Re: St. Lucie Unit 1
Docket No. 50-335
Revised Steam Generator Tube Inservice Inspection
Special Report for Refueling Outage SL1-19 & RAI Response

Replacement St. Lucie Unit 1
Spring 2004 Refueling Outage SL1-19
Steam Generator Tube Inservice Inspection
Special Report

**REQUEST FOR ADDITIONAL INFORMATION
SL1-19 STEAM GENERATOR TUBE INSERVICE INSPECTION SPECIAL REPORT
ST. LUCIE NUCLEAR PLANT, UNIT 1
DOCKET NUMBER 50-335**

FIGURE 1
PSL-1 Replacement Steam Generator Support Identification

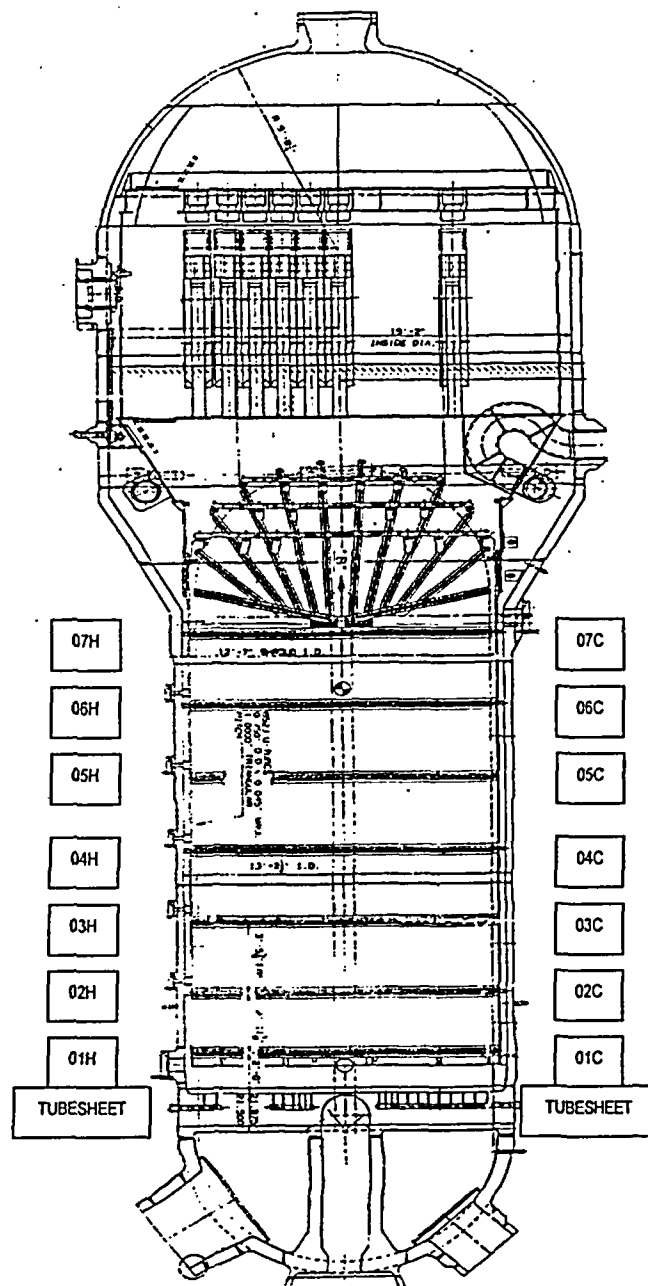
There is limited steam generator design information in the St. Lucie Updated Final Safety Analysis Report. In order for the staff to better understand the design of your steam generators and the location of the indications described in your reports, please provide the following design information for St. Lucie Unit 1: (a) the manufacturer's model number for the replacement steam generators, (b) tube manufacturer, (c) outer diameter and nominal wall thickness of tubes, (d) number of tubes in each steam generator, (e) tube pitch and pattern (e.g., 0.95 inches triangular), (f) tubesheet thickness (with and without clad), (g) a sketch depicting the tube support structure naming (h) anti-vibration bar (fan bar) design, (i) tube support material (e.g., 410 Stainless Steel), (j) a sketch of a tubesheet map which depicts the rows and columns of the tubes in the steam generators, (k) smallest U-bend radius in the steam generator and the radii of the row 1 tubes, (l) stress relief after bending of tubes (e.g., stress relief of the entire tube length for the tubes in rows 1 through 27).

(e) tube pitch and pattern (e.g., 0.95 inches triangular)	1.0 inch triangular
(f) tubesheet thickness (with/without clad)	21.875 inches / 21.50 inches
(g) a sketch depicting the tube support structure naming	See Figure 1
